Application No : 154764

Lot 308 Subdivision

Site Inspection 4 July 2019

D Nielsen and W Sanderson Shire of Carnarvon

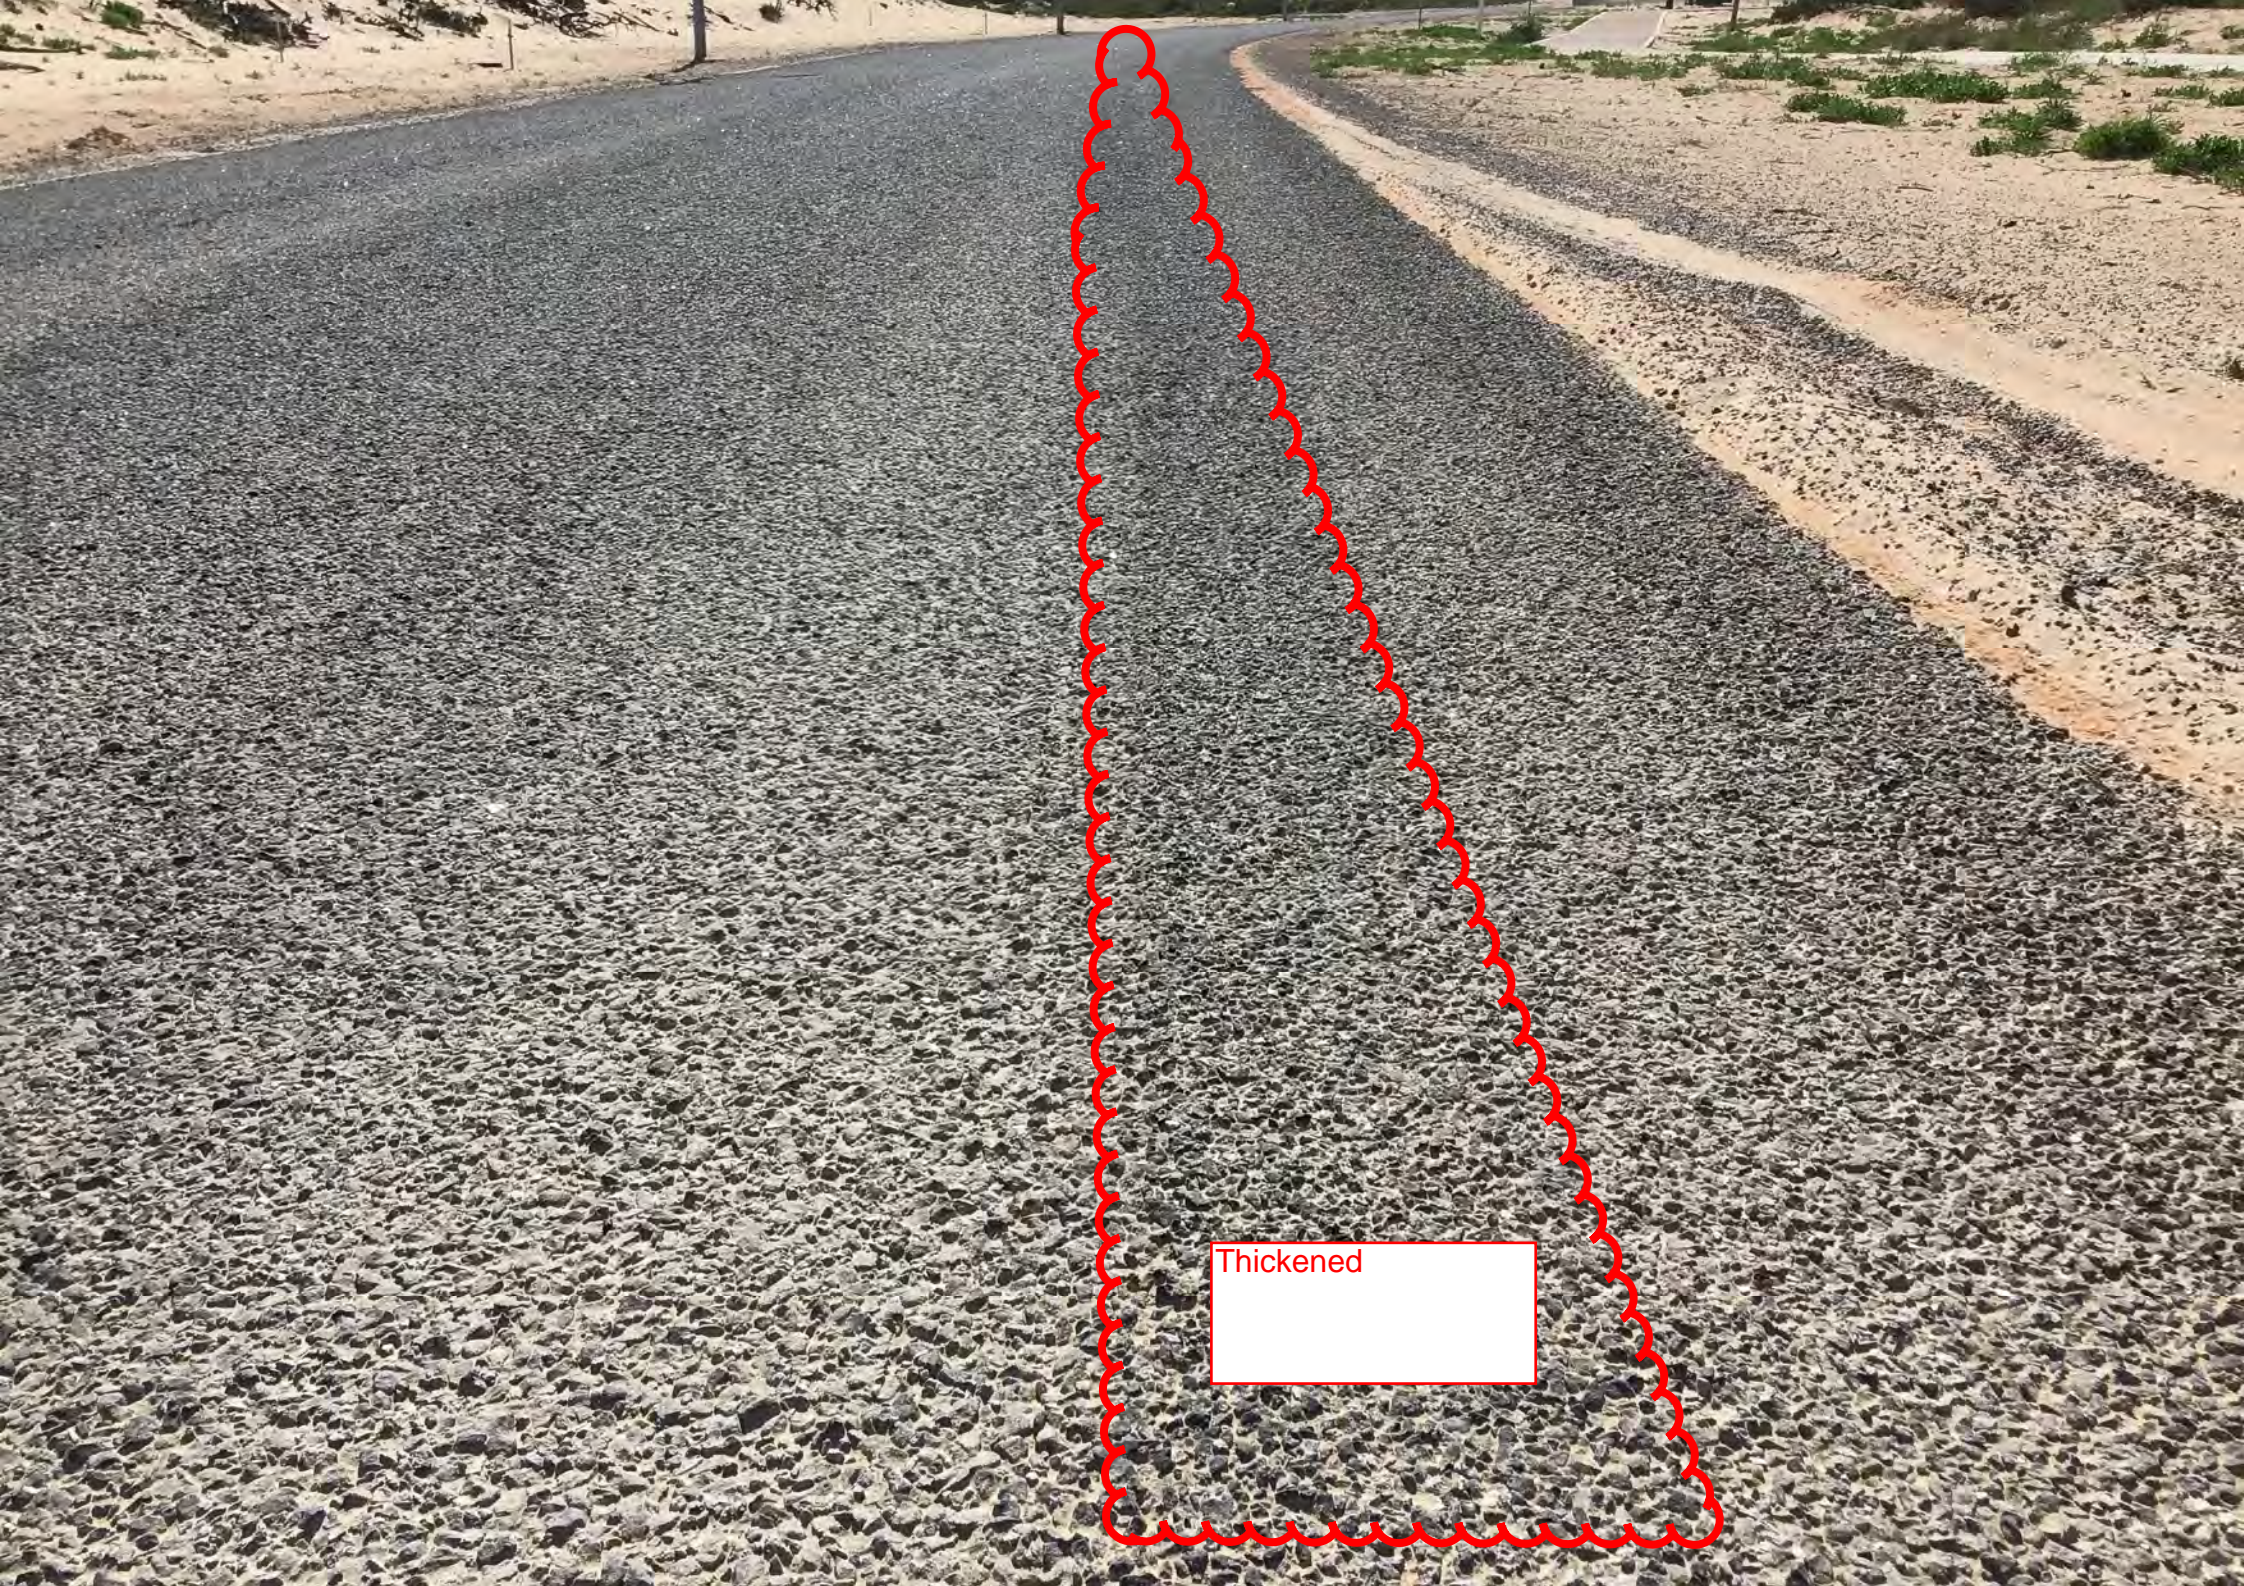
Possible Rutted Areas and/or Thickened Seal

- There were multiple examples of apparent rutted areas.
- On closer examination, the raised areas appear to be long strips of thickened seal.
- Possible cause is failure to leave a wet edge and/or poor spreading operations resulting in there being a doubling of the completed aggregate depth for extended lengths.
- Regardless of the cause, these areas are likely to hold and not shed water as a proper newly constructed road surface should do and a rectification will need to be employed to ensure water sheds properly.

This area will hold water

This area will hold water

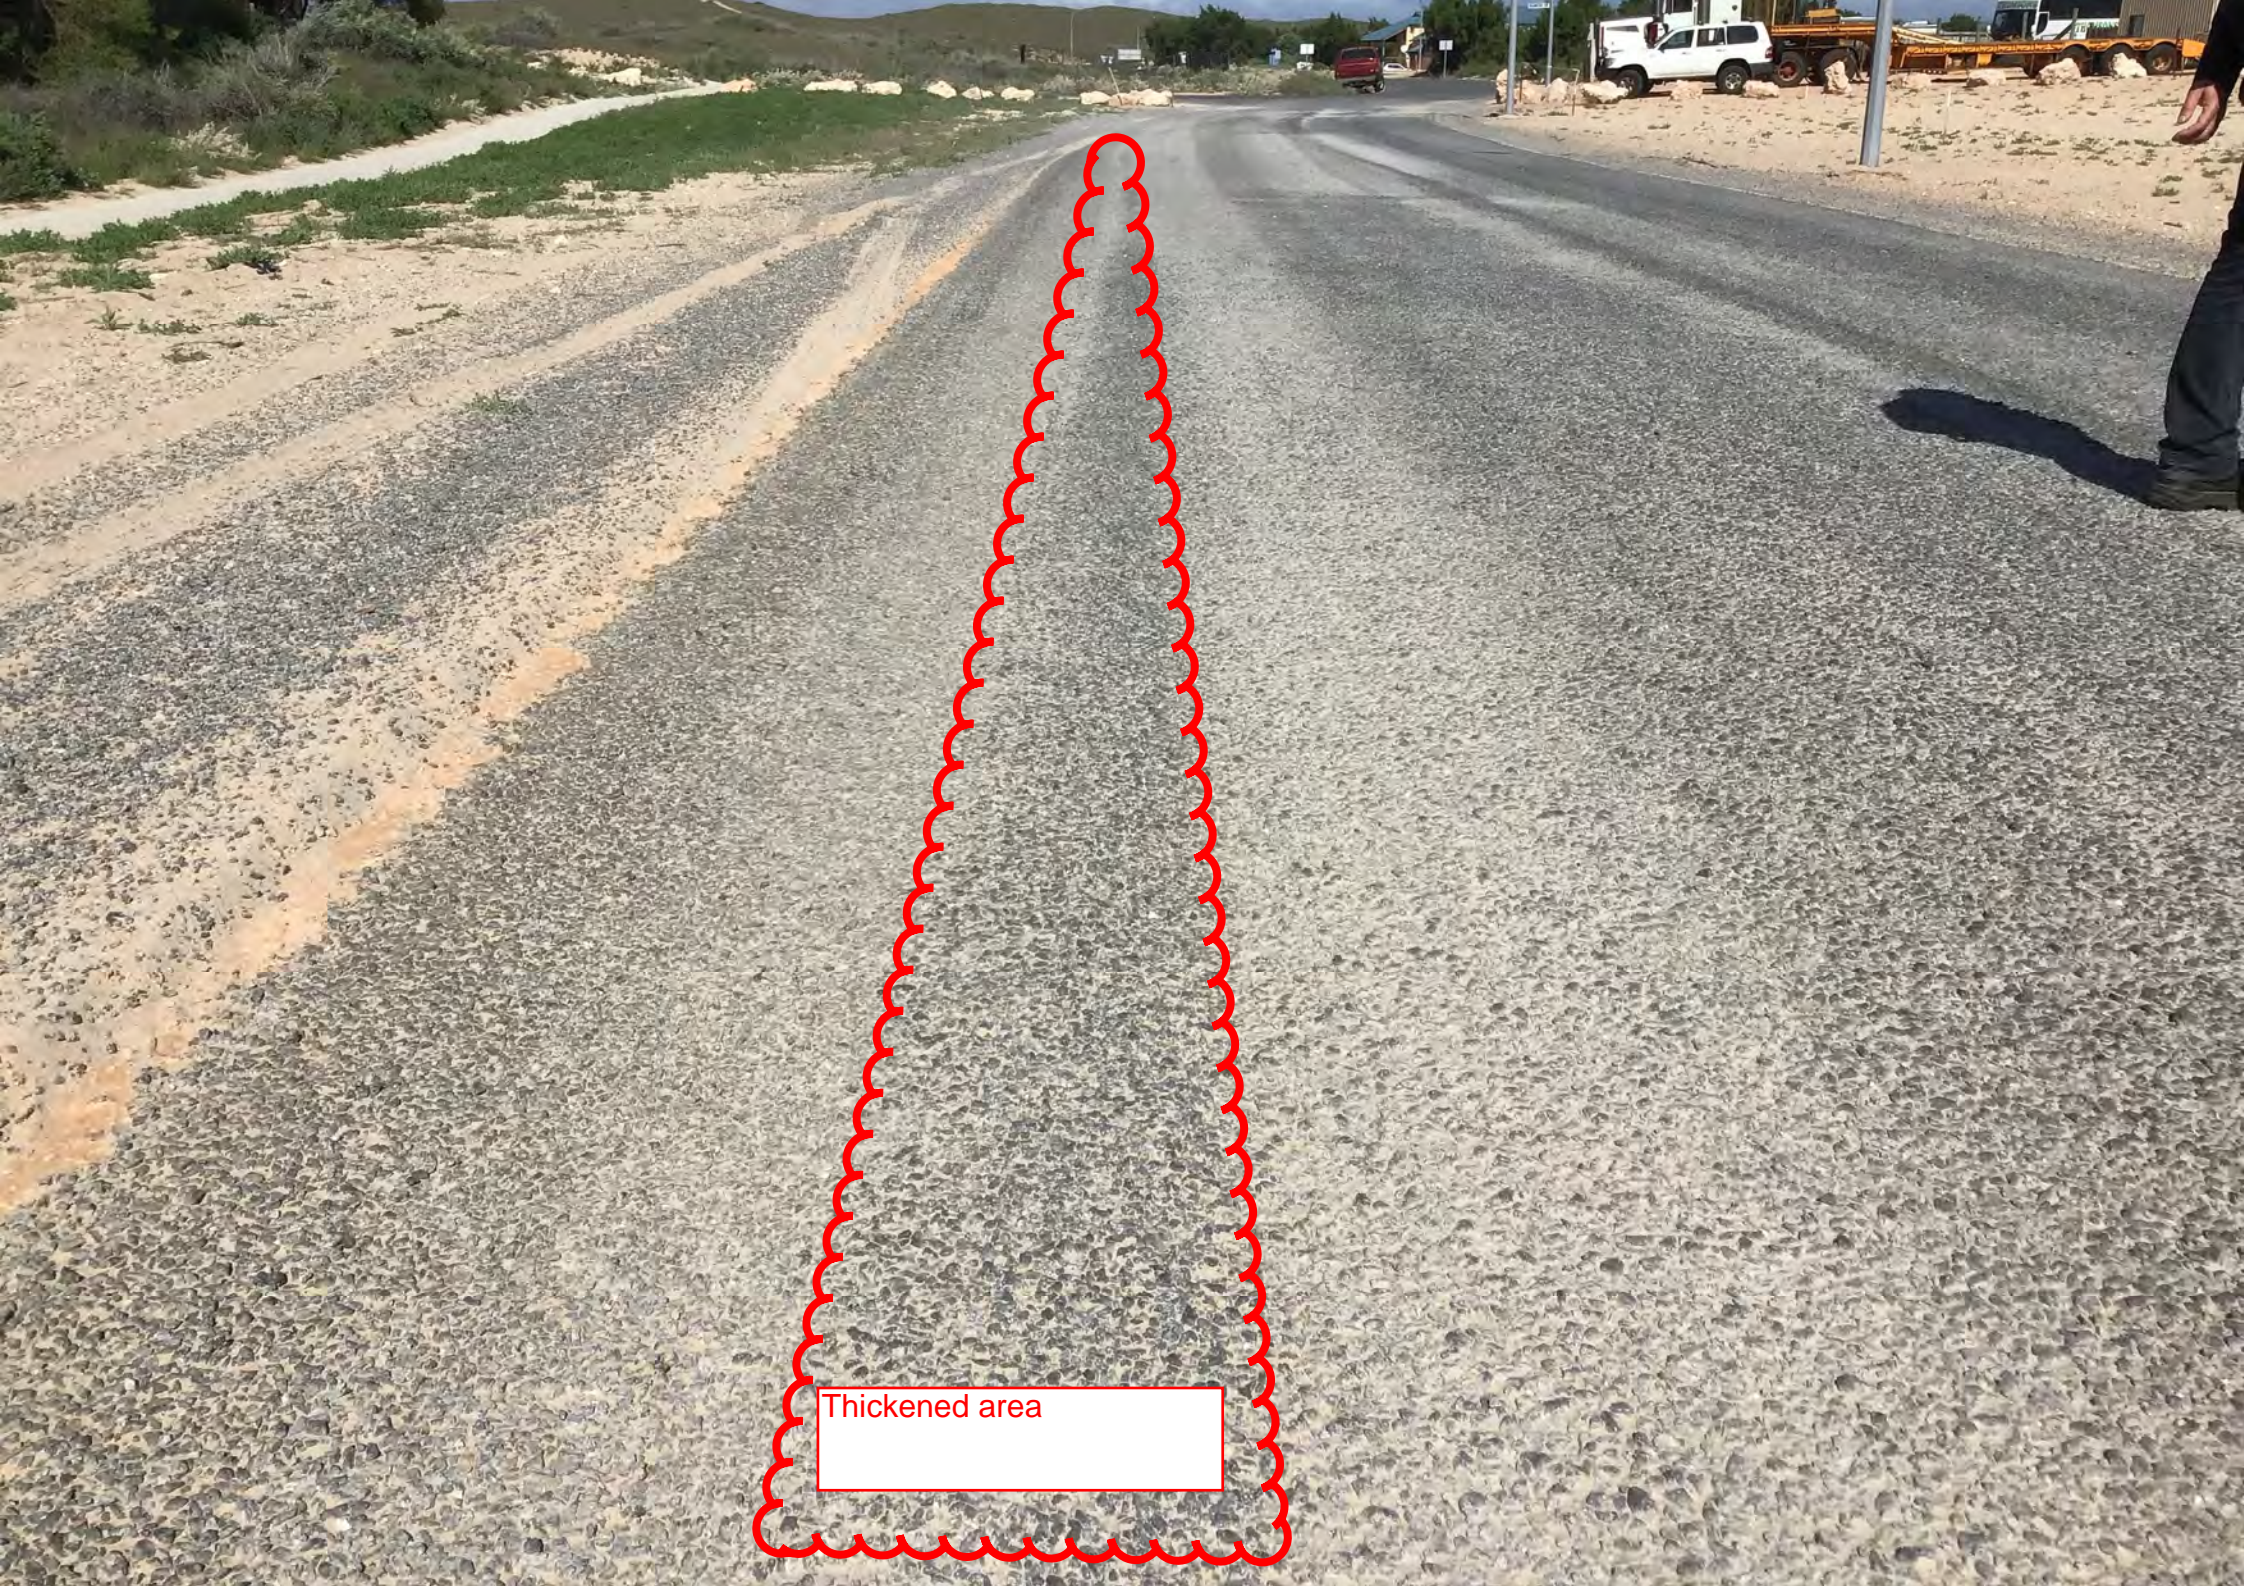
Thickened area

Thickened
